Beaches Link and Gore Hill Freeway Connection

Introduction, overview of engagement and submissions received, refinements and clarifications

November 2021

Figure A4-1 Overview of the Beaches Link and Gore Hill Freeway Connection project, including the refined alignment of the shared user bridge across Wakehurst Parkway (update to Figure 5-9 of the environmental impact statement)

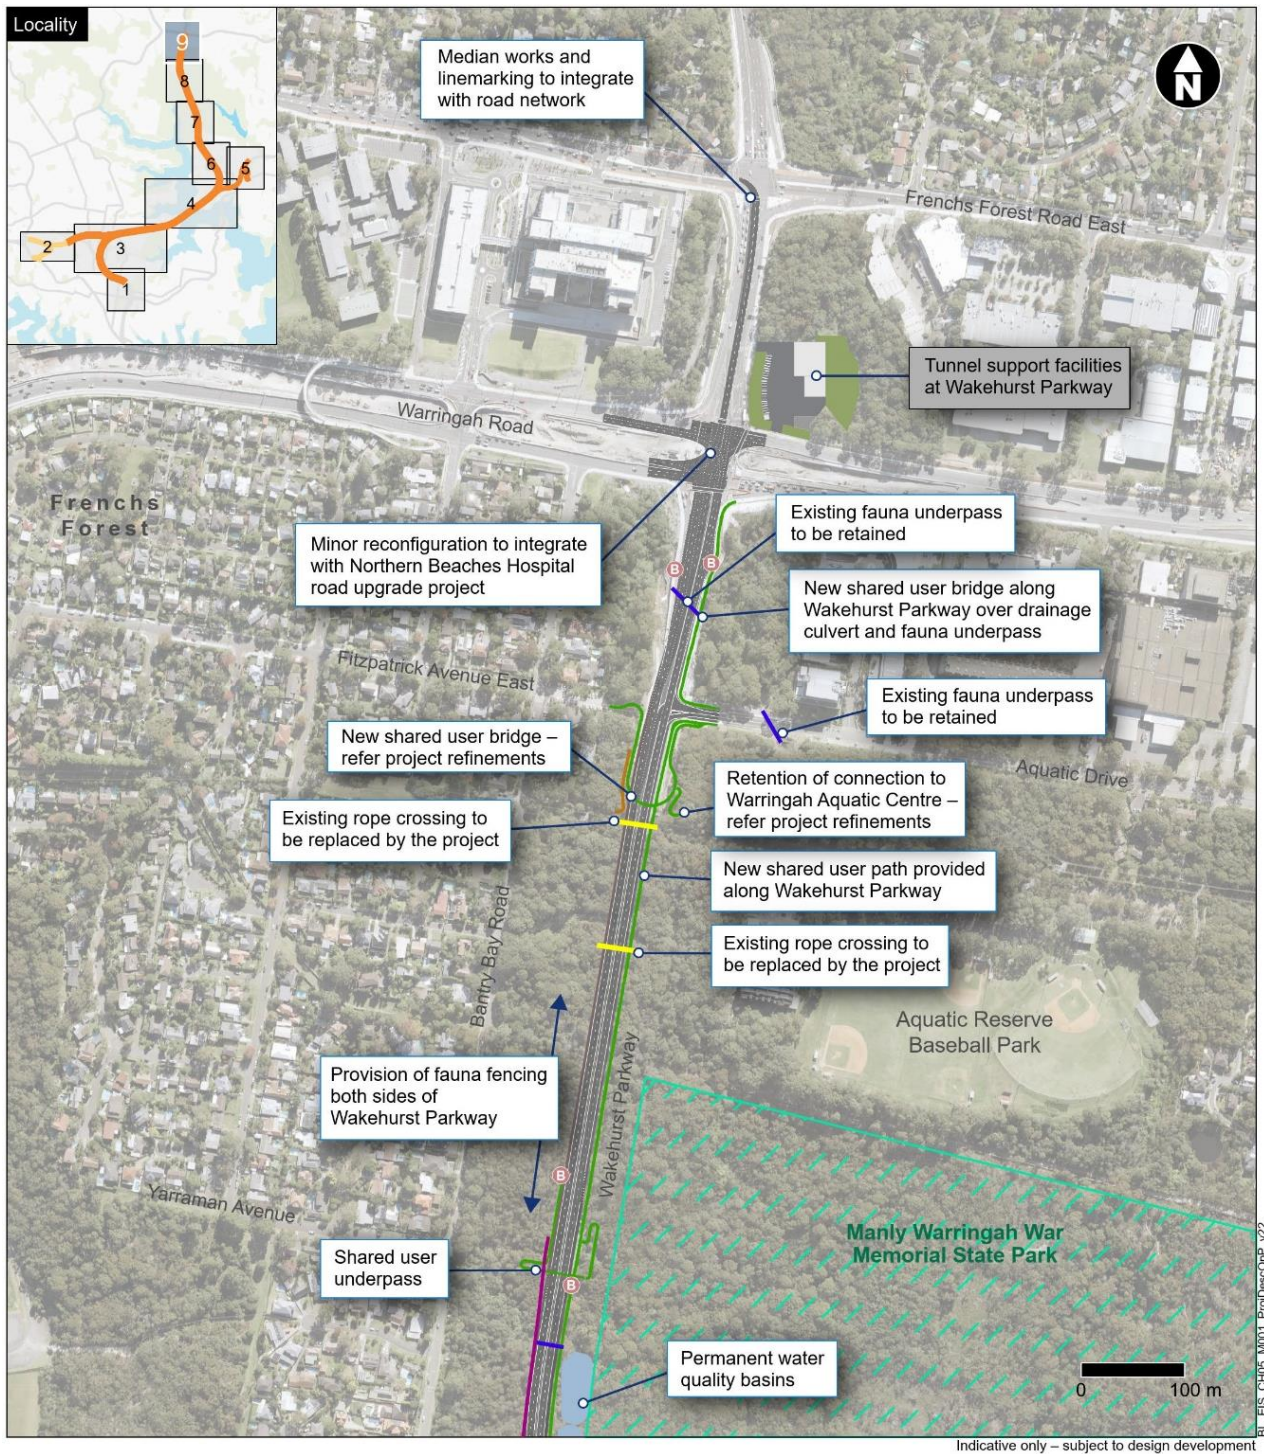
The proposed refinement is shown in Figure A4-1.

The proposed design consists of a distinctive curvilinear bridge with the centre of the bridge above Wakehurst Parkway, generally consistent with the original alignment about 350 metres south of Warringah Road at Frenchs Forest. The refined curvilinear design is consistent with the urban design theme of two shared user bridges recently constructed by Transport for NSW including the connection of Hilmer Street with the Northern Beaches Hospital Precinct. The bridge ramps would meet ground level about 80 metres north of the original alignment, at Aquatic Drive to the east of Wakehurst Parkway and Fitzpatrick Avenue East to the west of Wakehurst Parkway. To provide connectivity along the future pedestrian and cyclist corridor, the curvilinear bridge design is required due to constraints including but not limited to:

Figure A4-2 Overview of construction activities and construction footprint, including revised construction footprint for the refined alignment of the shared user bridge across Wakehurst Parkway (update to Figure 6-29 of the environmental impact statement)

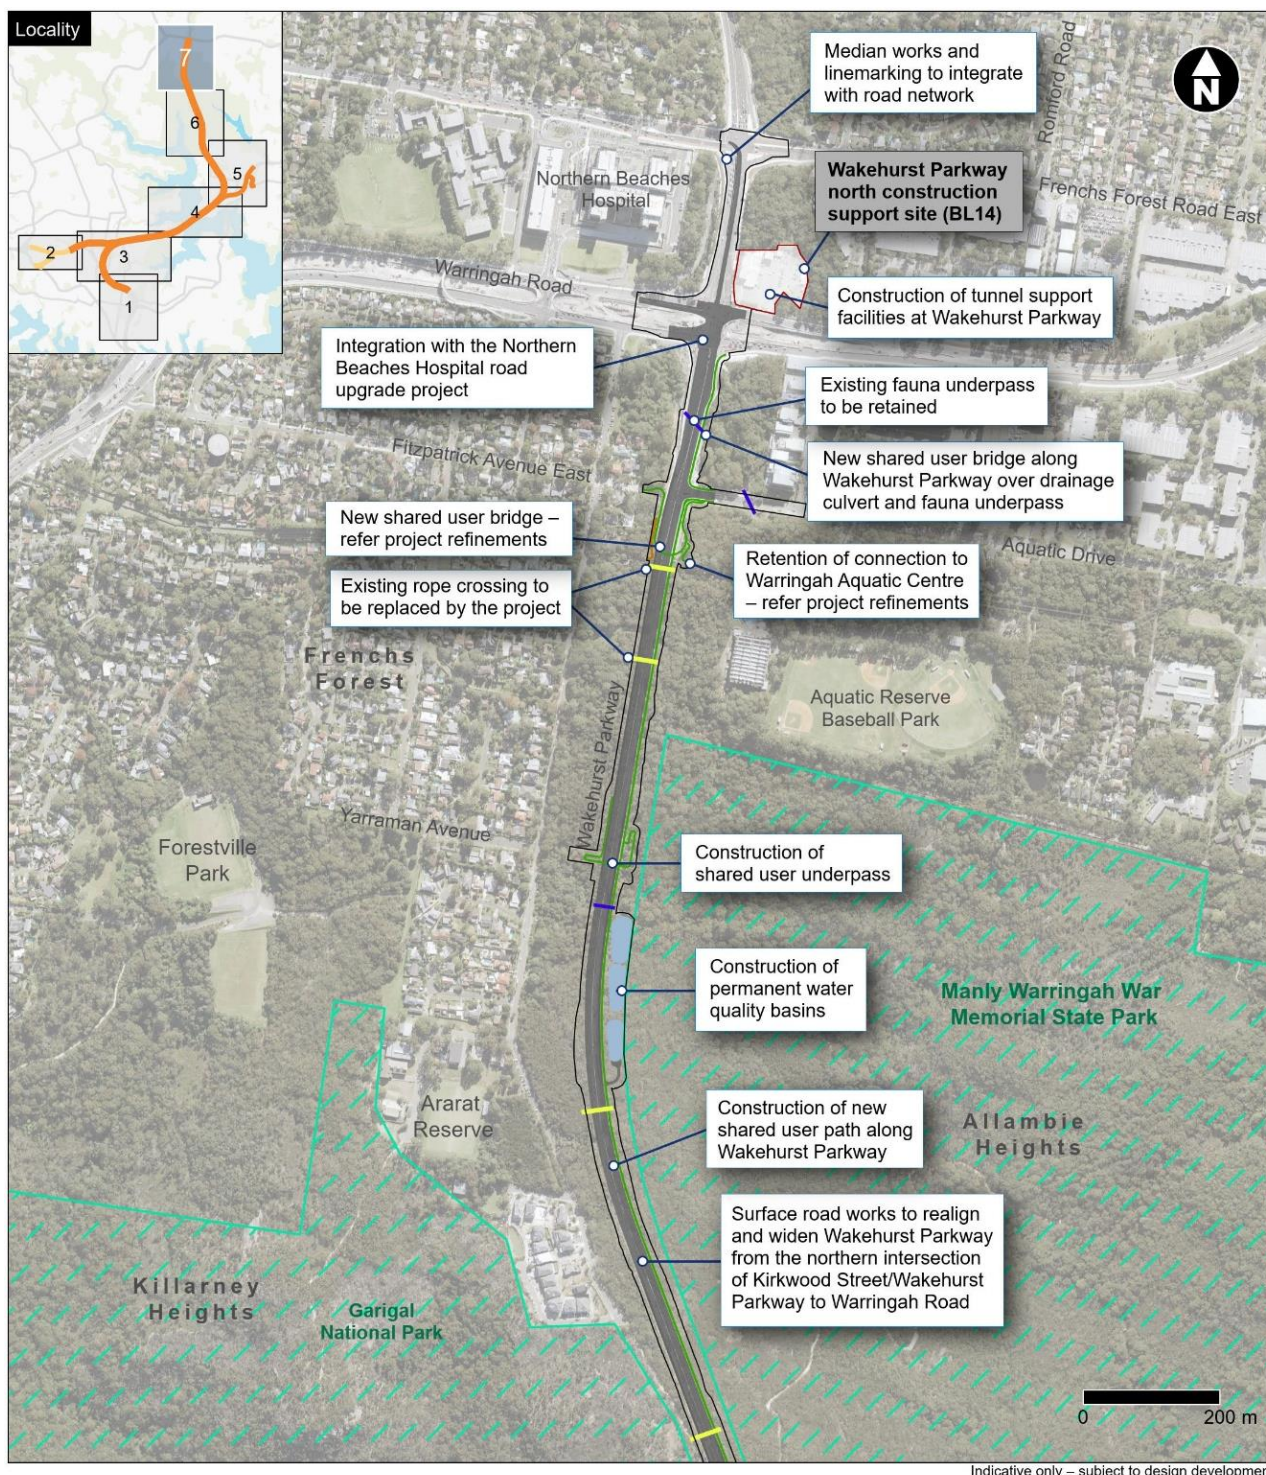
The proposed refinement would reduce the projects land requirements and the construction and operational footprint by about 1228 square metres. The refined construction footprint is shown in Figure A4-2.

Figure A4-3 Changes in vegetation impacts from the realignment of the Wakehurst Parkway shared user bridge ramps

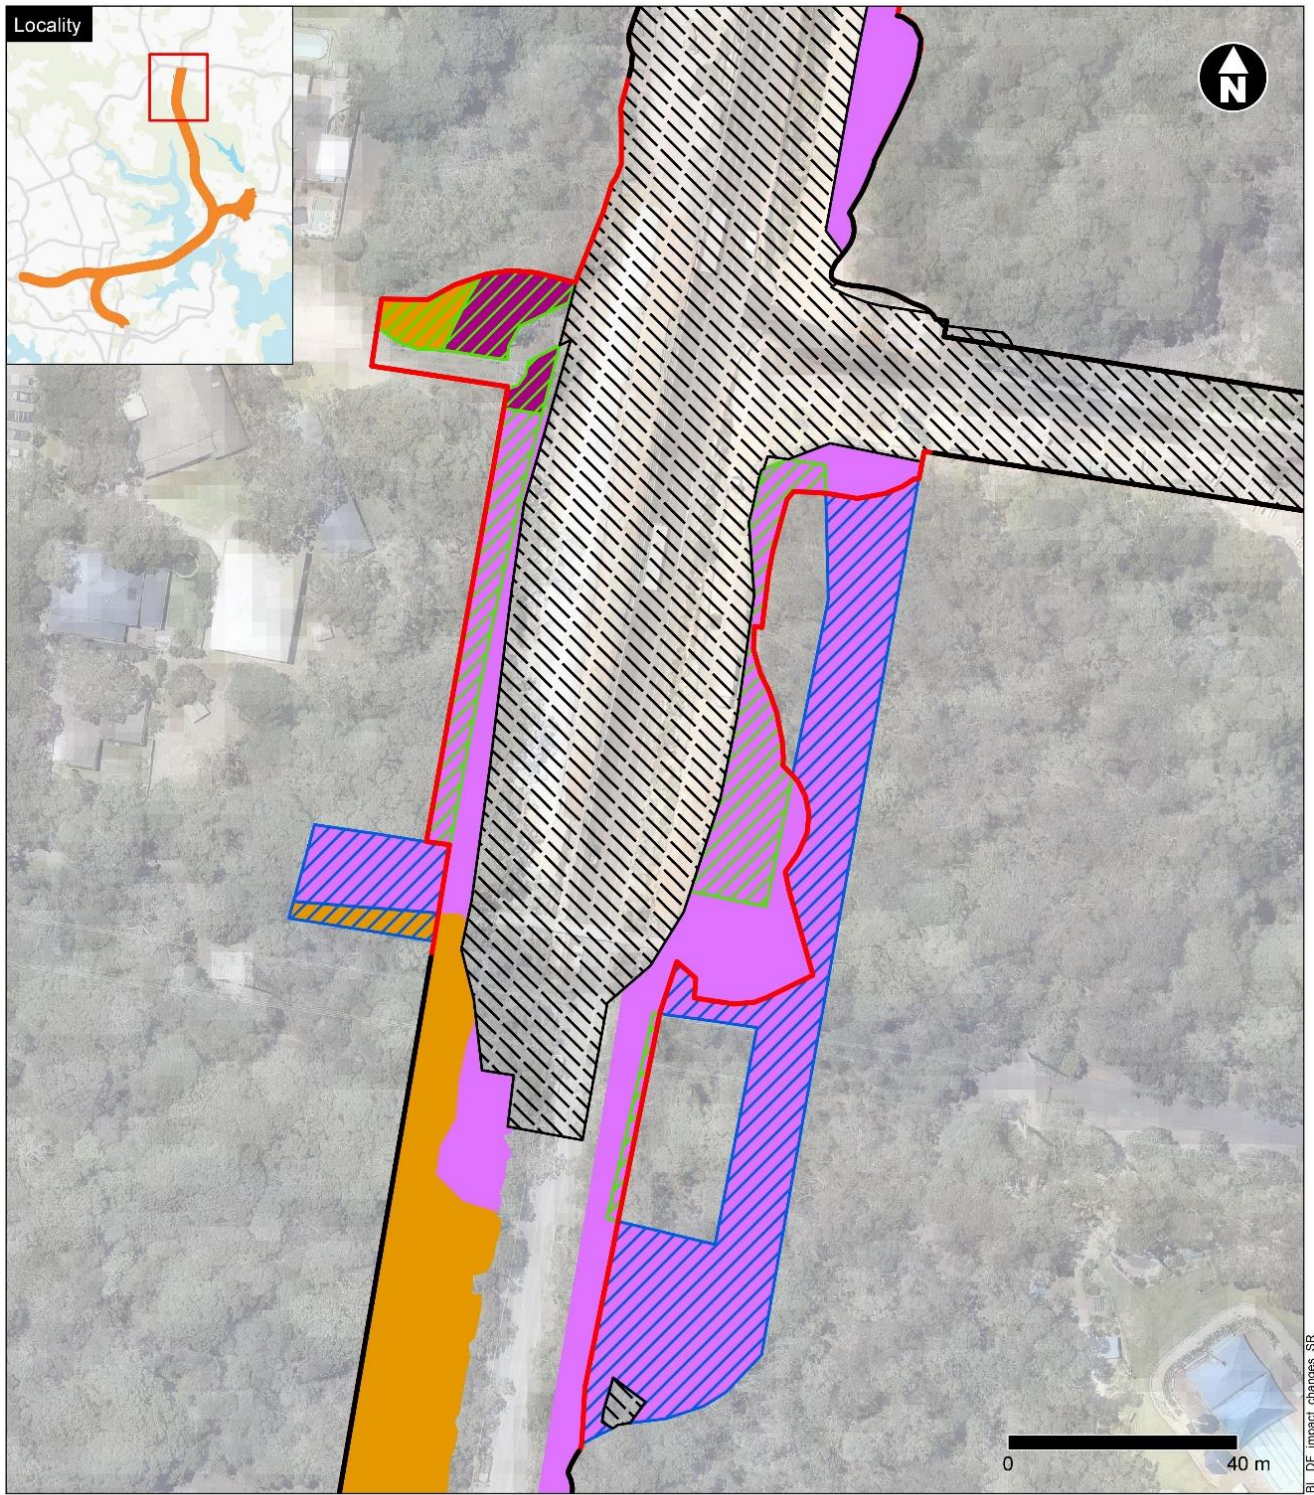
The proposed refinement and associated reduction in impacts to vegetation is shown in Figure A4-3.

With consideration of the above and reclassification of PCT 1292 (refer to Section B4.4 of this submissions report), a revised biodiversity credit calculation has been carried out and is provided in Appendix F2 of this submissions report. A summary of the key updates to ecosystem and species credits due to the proposed design refinement includes:

- PCT 1786 (Duffys Forest endangered ecological community) direct ecosystem credits reduced from 43 to 36 and overall direct ecosystem credits for the project reduced from 391 to 383
- PCT 1786 (Duffys Forest endangered ecological community) indirect ecosystem credits reduced from 14 to nine and overall indirect ecosystem credits for the project reduced from 50 to 45
- Species credits for Eastern Pygmy-possum (*Cercartetus nanus*) reduced from 403 to 397
- Species credits for Large-eared Pied-bat (*Chalinobus dwyeri*) reduced from 670 to 658

Overall species credits for the project reduced from 1099 to 1081.

Figure A5-1 Section AA – Wakehurst Parkway (Update to Section AA figure from Appendix V (Technical working paper: Urban design, landscape character and visual impacts, page 172)

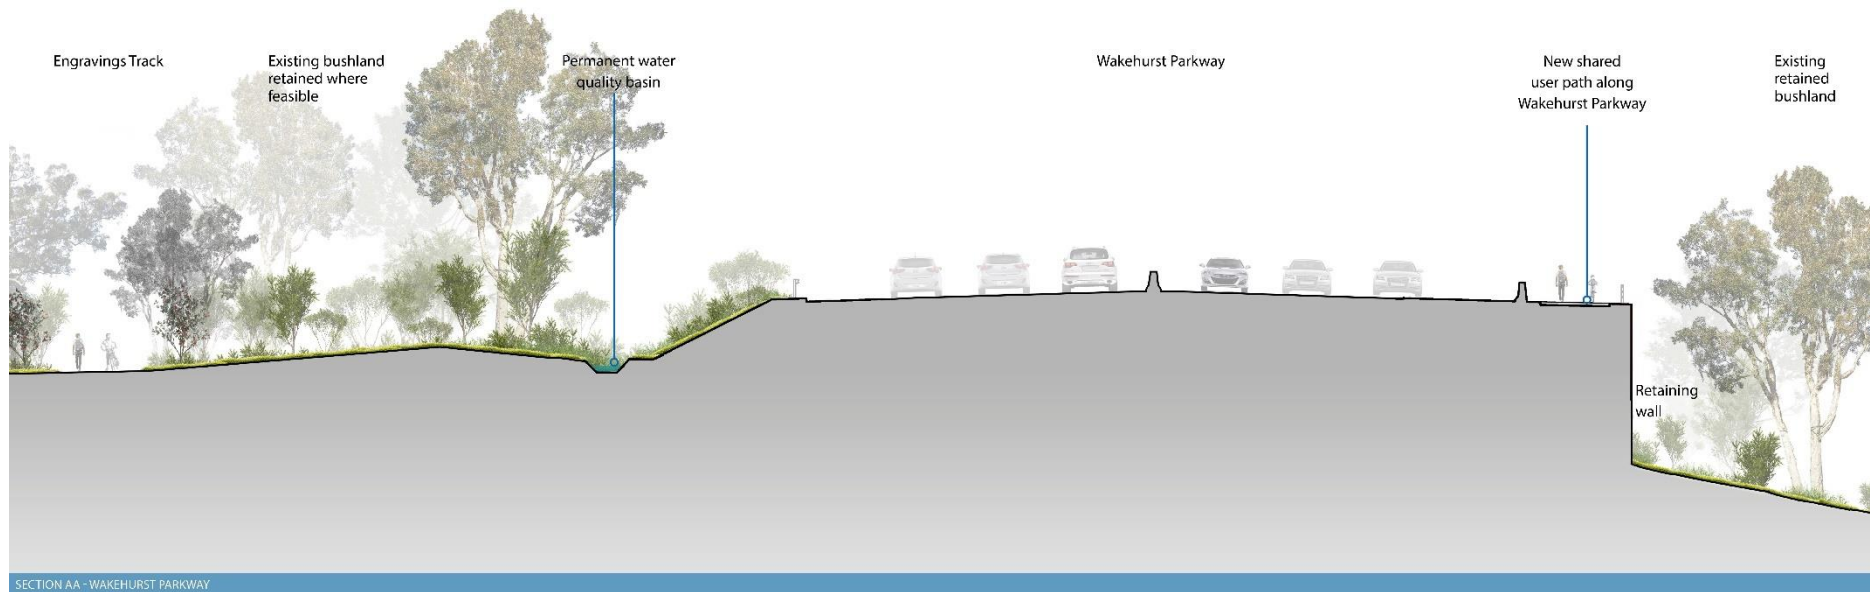
The cross sections AA and BB on page 172 of Appendix V (Technical working paper: Urban design, landscape character and visual impacts) have been updated to show the provision of this safety barrier, with the updated cross sections provided in Figure A5-1 and Figure A5-2 of this submissions report.

Figure A5-5 Overview of the Beaches Link and Gore Hill Freeway Connection project (map 1) (update to Figure 5-1 of the environmental impact statement)

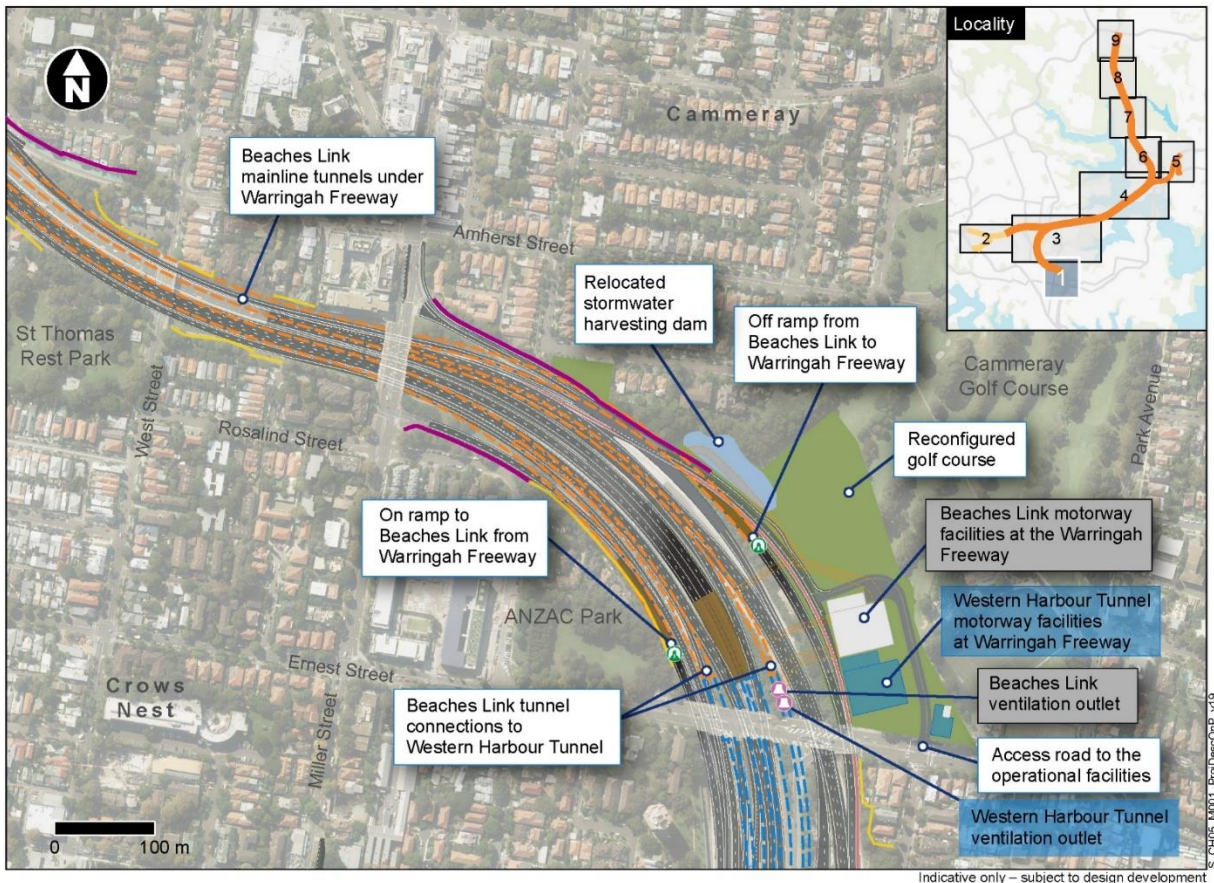
Chapter 5 (Project description), Figure 5-1	Further detail added to depict southbound bus lane on the Warringah Freeway	As outlined in Table 5-9 of the environmental impact statement, buses travelling southbound in the Beaches Link tunnel would be provided with direct access to a new southbound bus lane on the Warringah Freeway. Figure 5-1 of the environmental impact statement has been updated to show the bus lane included in the Warringah Freeway Upgrade (refer to Figure A5-5 below). The transition for buses moving from the Beaches Link tunnel southbound general traffic lanes into the bus lane would occur on the surface of the Warringah Freeway, roughly in the area between Ernest Street and Falcon Street.

Figure A5-6 Overview of the Beaches Link and Gore Hill Freeway Connection project (map 2) (update to Figure 5-2 of the environmental impact statement)

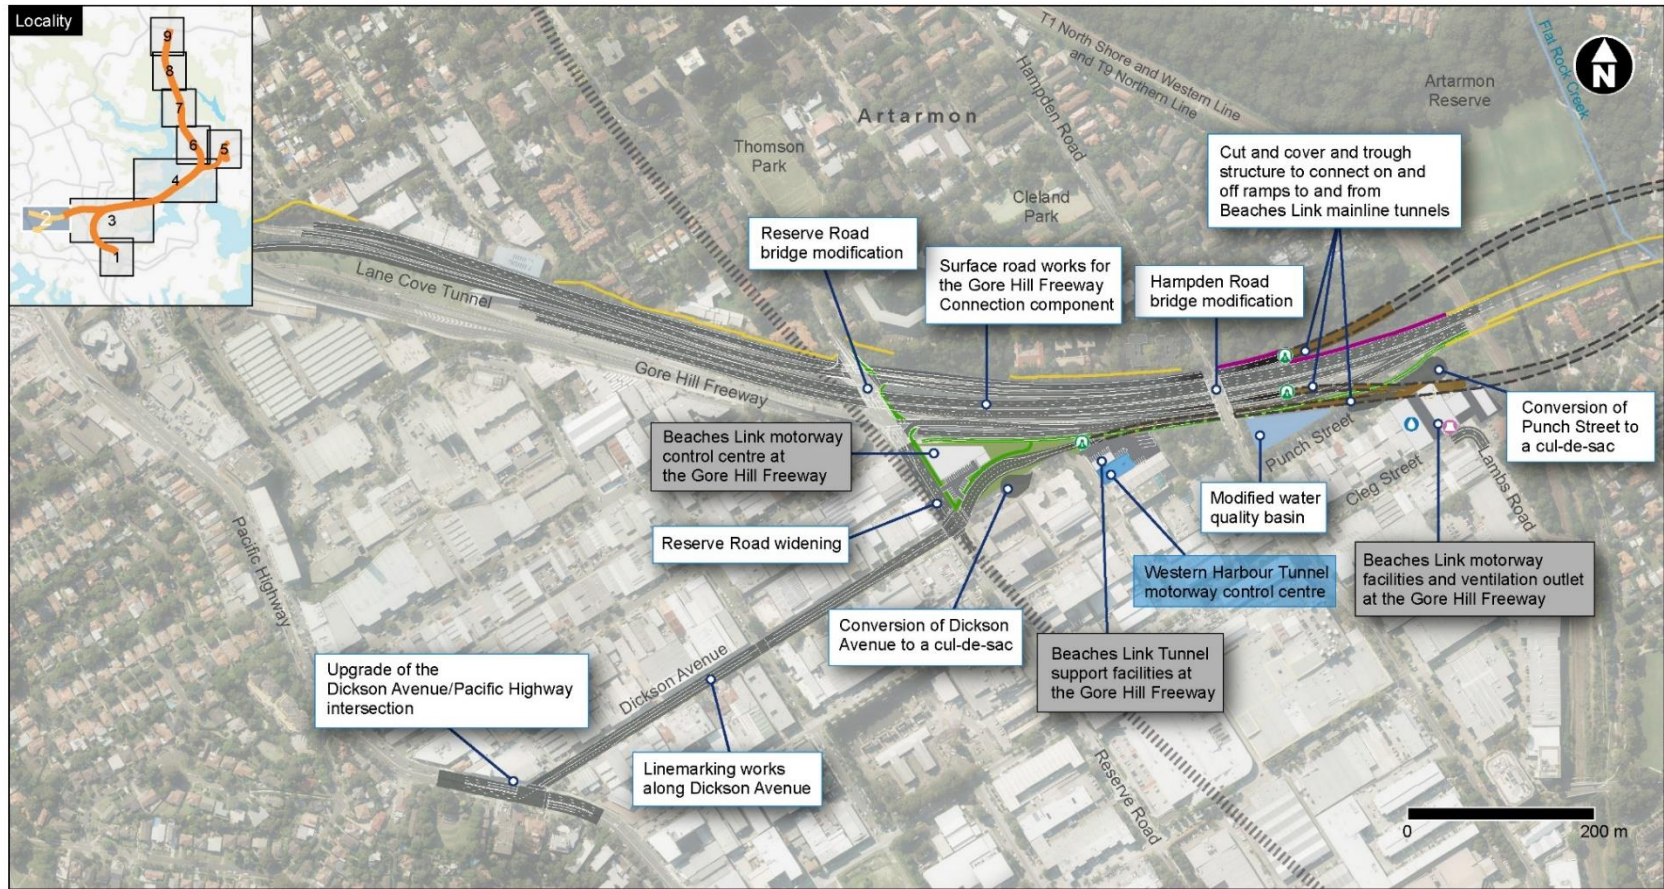
Chapter/Appendix reference	Error/discrepancy	Clarification
Chapter 5 (Project description), Figure 5-2	Further detail added to depict eastbound and westbound traffic lanes on Dickson Avenue, west of Reserve Road	Figure 5-2 of the environmental impact statement has been updated to better represent line marking on Dickson Avenue (refer to Figure A5-6 below). To confirm, changes to Dickson Avenue would not include reducing Dickson Avenue to a single lane/ one way traffic. No configuration changes are proposed for Curry Lane and Carlotta Street.
Chapter 5 (Project description), Figure 5-5	Error in mapping	Figure 5-5 of the environmental impact statement shows a grey box on the left-hand side of the figure adjacent to the 'Localised adjustment of Burnt Bridge Creek' label. This box is covering some houses and was included in error on the figure. No impact to these properties is proposed as is indicated in Chapter 20 (Land use and property) of the environmental impact statement.
